REDD+ PROJECT RESGUARDO INDÍGENA UNIFICADO – SELVA DE MATAVÉN (RIU-SM)

Project Title	REDD+ PROJECT RESGUARDO INDÍGENA UNIFICADO – SELVA DE MATAVÉN (RIU-SM)
Version	Version 01.1
Report ID	ESSPL/VCS/2018/056

Report Title	Verification of “REDD+ PROJECT RESGUARDO INDÍGENA UNIFICADO – SELVA DE MATAVÉN (RIU-SM)”
Client	MEDIAMOS F&M S.A.S
Pages	52
Date of Issue	19/11/2018
Prepared By	EPIC Sustainability Services Pvt. Ltd
Contact	EPIC Sustainability Services Pvt. Ltd. No. 41, Anugraha, 1st Cross Road, Sundarnagar, Near BEL Circle, Gokula Extension, Bengaluru - 560 054, Karnataka State, India. Email: info@epicsustainability.com, epicsustainability@gmail.com Phone: +91 94827 59072, +91 95909 29935 Website: http://www.epicsustainability.com/
Approved By	Mr. K. Sudheendra (Head-Operations)
Work Carried Out By	Dr. G.Vishnu (Lead Auditor) Dr. R. Madhukar (Auditor)

Illustration 1. Change over the Guaviare river

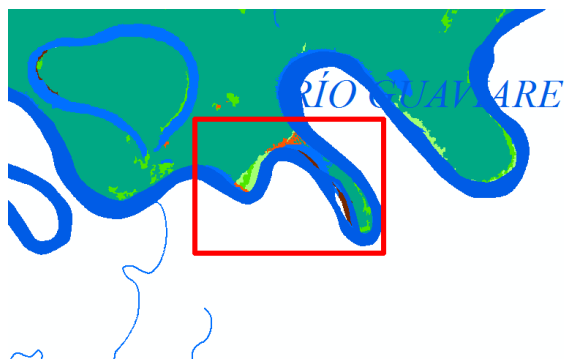
The identified changes of land coverage from Primary Forest and Flooded Primary Forest (in December, 2015) to Bare Soil (in December, 2017), correspond to natural changes typical of the geomorphology of the alluvial plains, where the interaction between rivers and their banks generates changes in the land coverages. Parts of the "2016-2017 coverage map" ("map5_general_coverage_2016_2017.pdf" in folder "general_maps") show three zones where this change has occurred, and all of them are adjacent to the rivers. Below are the 3 illustrations of this type of land coverage change:

The changes from "Forest" to "Bare Soil" correspond to natural changes adjacent to the river banks or wetlands typical of the geomorphology of the rivers in this region.

In illustration 1, a change in the riverbed can be observed, producing the generation of "beaches" or
